ATTACHMENT 2

Letter from C.R. Steinhardt (WPSC)

Proposed Amendment 111

Affected TS Pages

FIGURE TS 3.10-2

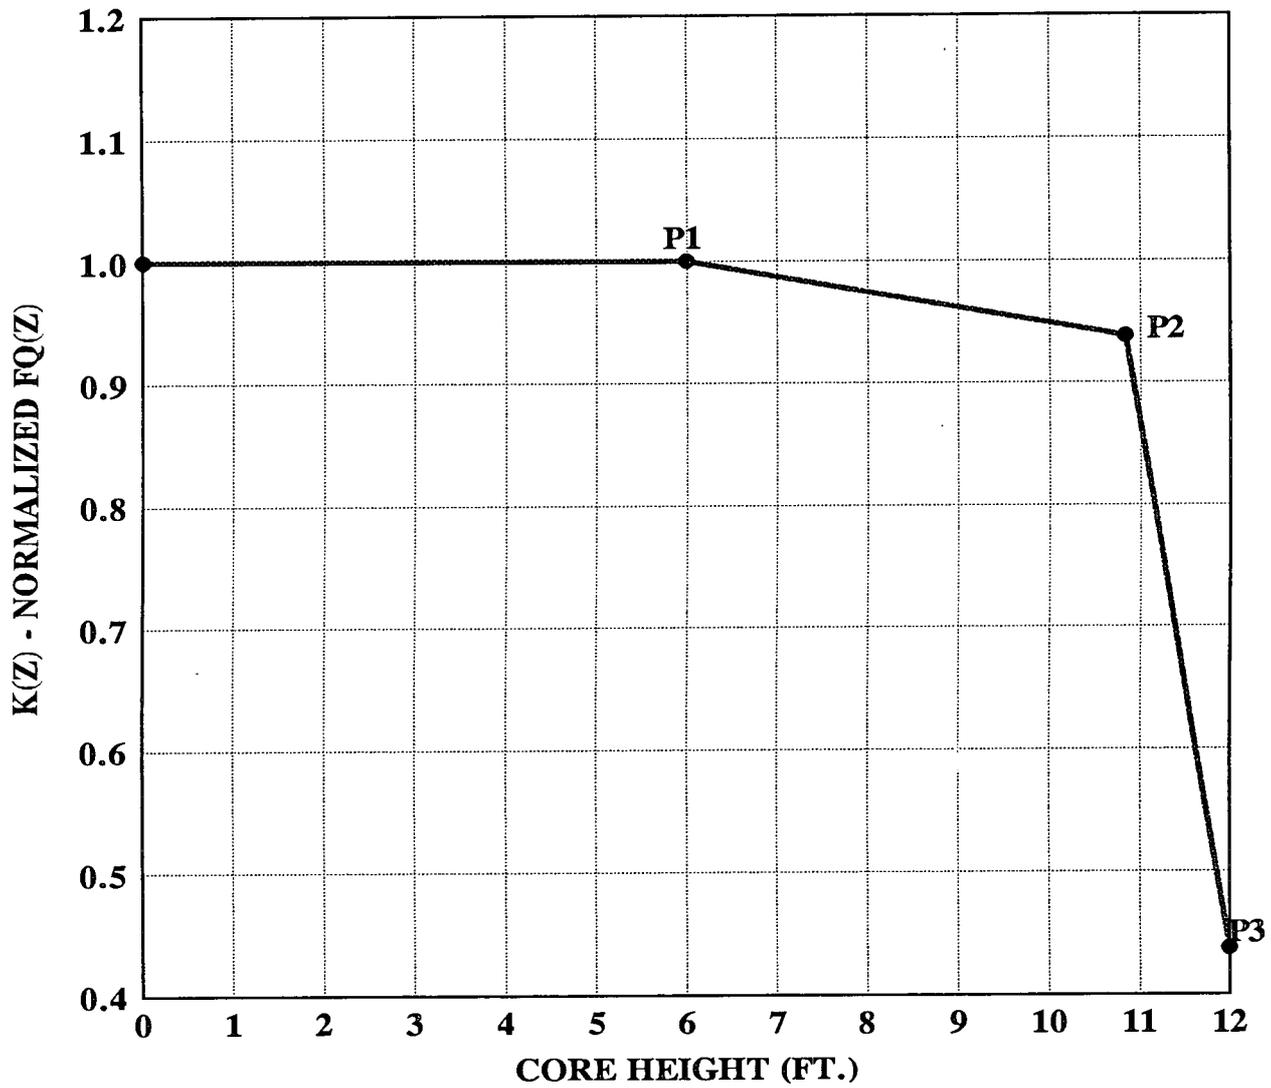
A. $F_q^N(Z)$ Limits for Siemens Power Corporation Fuel

$$F_q^N(Z) \times 1.03 \times 1.05 \leq (2.28)/P \times K(Z) \text{ for } P > .5$$

$$F_q^N(Z) \times 1.03 \times 1.05 \leq (4.56) \times K(Z) \text{ for } P \leq .5$$

K(Z) is the function given in Figure TS 3.10-2

| Siemens Power Corporation Fuel K(Z) Coordinates |
| P1 (6, 1.0) |
| P2 (10.84, 0.938) |
| P3 (12, 0.438) |
| Normalized to 2.28 |
